3 August 2010

File No: W10/418

Request for Provision of Details of Key Issues and Assessment Requirements – Major Project Application MP10_0104 Public Domain Upgrade Works, The Rocks

Fig. 09 - Circular Quay West - Concept Option

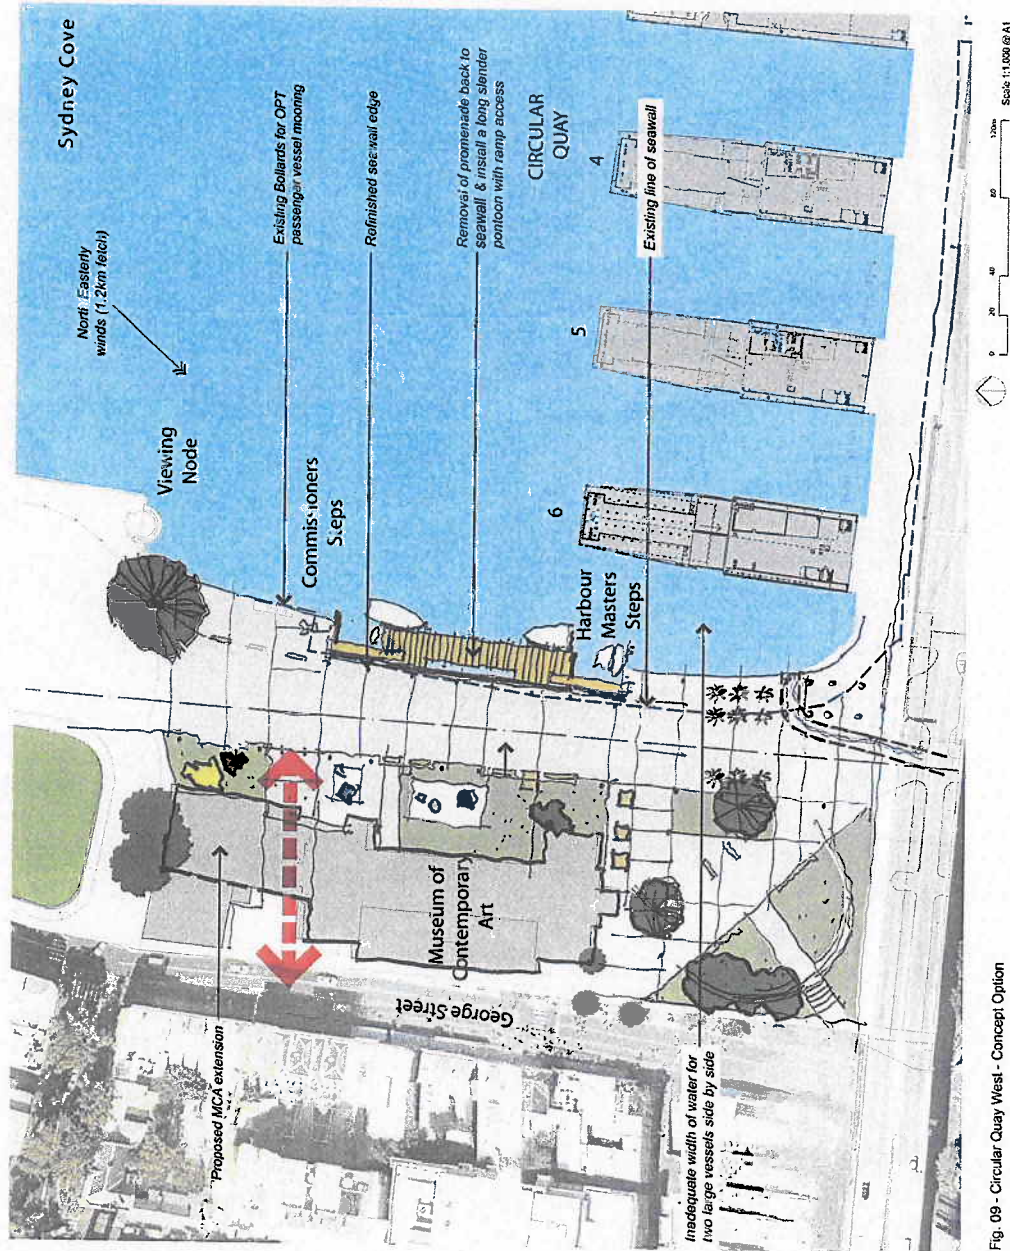
1. NSW Maritime's proposal to replace the existing Harbour Masters and Commissioners steps area with a new long slender pontoon. Under NSW Maritime's Sydney Cove Maritime Infrastructure Options Plan, it is intended to replace the existing Harbour Masters and Commissioners steps area with a new long slender pontoon as shown on the attached drawing. This proposal will overcome the current position at both locations where passengers must risk boarding from narrow steep steps that are exposed to high winds and vessel wash.

In doing so it will be necessary to remove the section of the existing promenade in front of the seawall in order to create safe berthing and not to conflict with usage at Circular Quay Wharf 6 and the Overseas Passenger Terminal. This will necessitate a redesign of the pedestrian promenade access at Circular Quay West, thereby reducing the area available to landscaping.

3. Real Property issues relation to the western promenade. While it is true the pavement area is SHFA property, at no point in the document does it acknowledge that this area is on top of NSW property and that NSW have plans to return this area to its original alignment as shown on the attached plan. The promenade is in fact a walkway on top of a NSW wharf. The wharf requires continuous maintenance and the substructure is beyond its useful economic life. The West Circular Quay proposal should therefore address this issue in regard to NSW Maritime plans for its land.
